To: Town of Worthington Planning Board

From: BWC Wades Stream, LLC

Subject: Response to Worthington Fire-Rescue Department Comment for the Special Permit Petition and Site Plan Review for BWC Wades Stream, LLC LSGMSPI

Appendix A: Illustrative Fire Alarm System Matrix

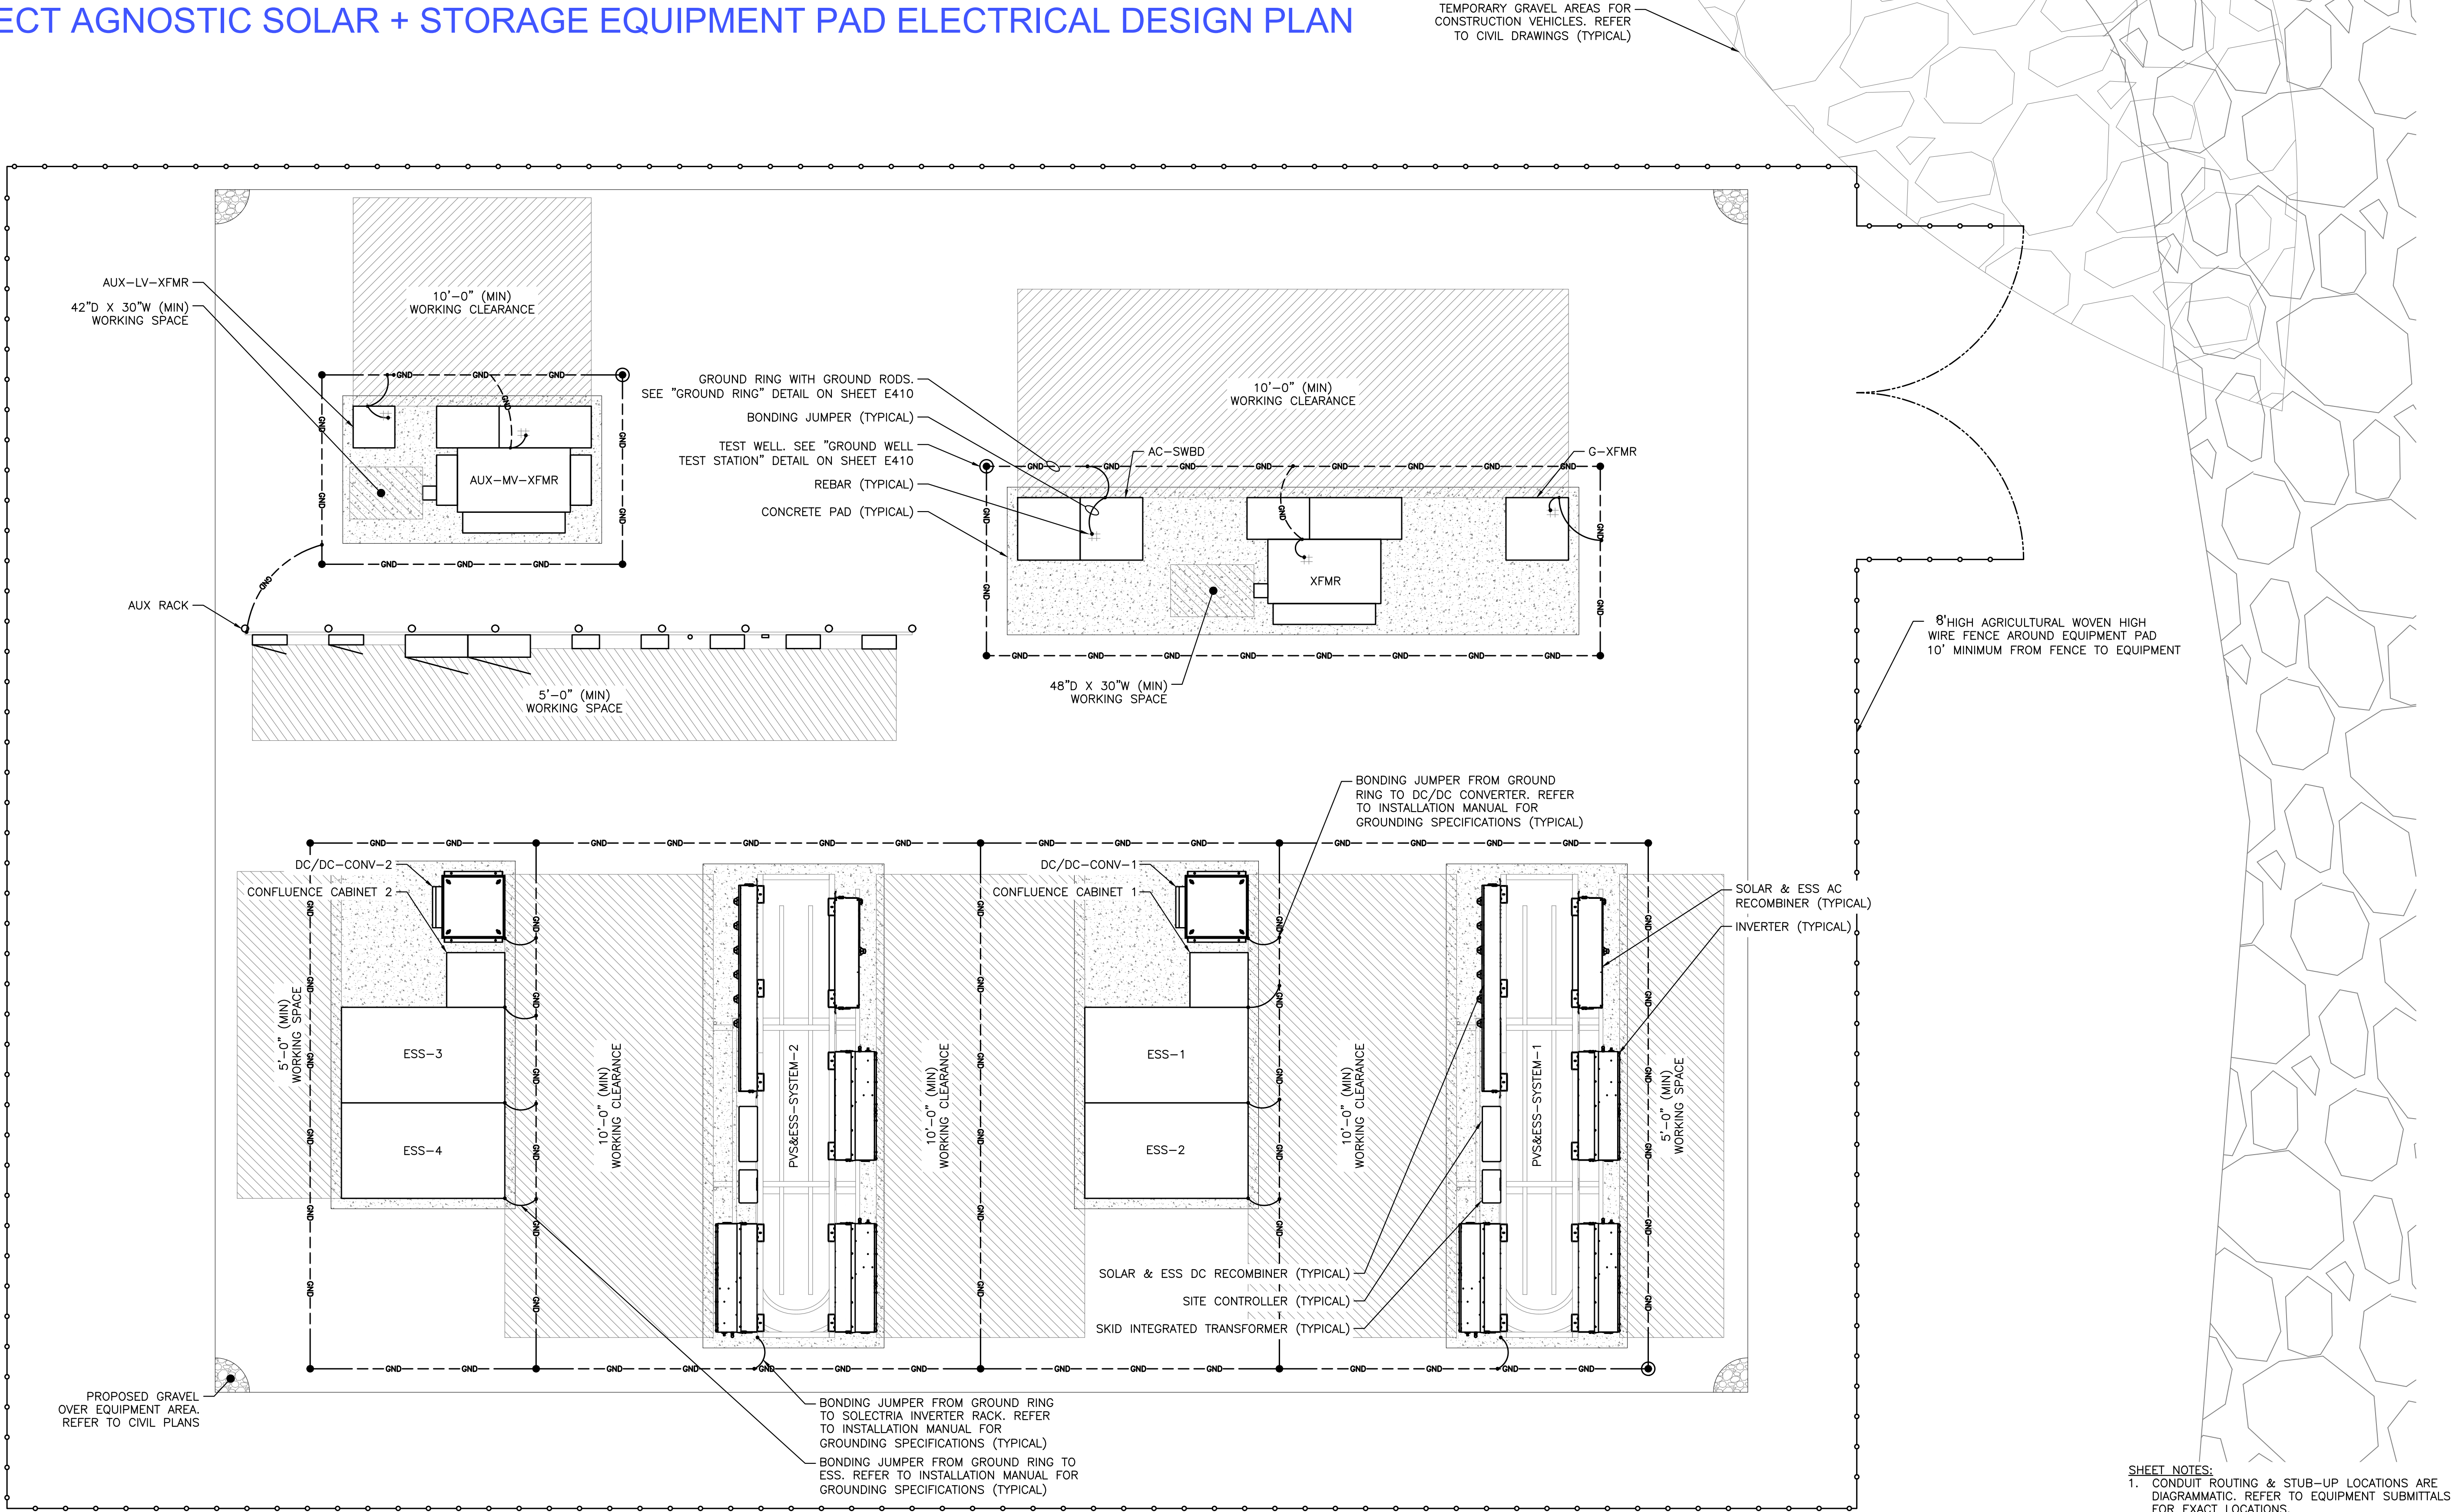
7a. An example, illustrative fire alarm system conceptual design matrix, including dial-out functionality, is included in Appendix A of this submittal.

9. An example, illustrative fire alarm system conceptual design matrix, including dial-out functionality, is included in Appendix A of this submittal. We have no objection to a condition that the Fire Chief receive a 90-day window to review the final fire alarm design matrix prior to building permit issuance.

3. An example, illustrative fire alarm system conceptual design matrix, including dial-out functionality, is included in Appendix A of this submittal.
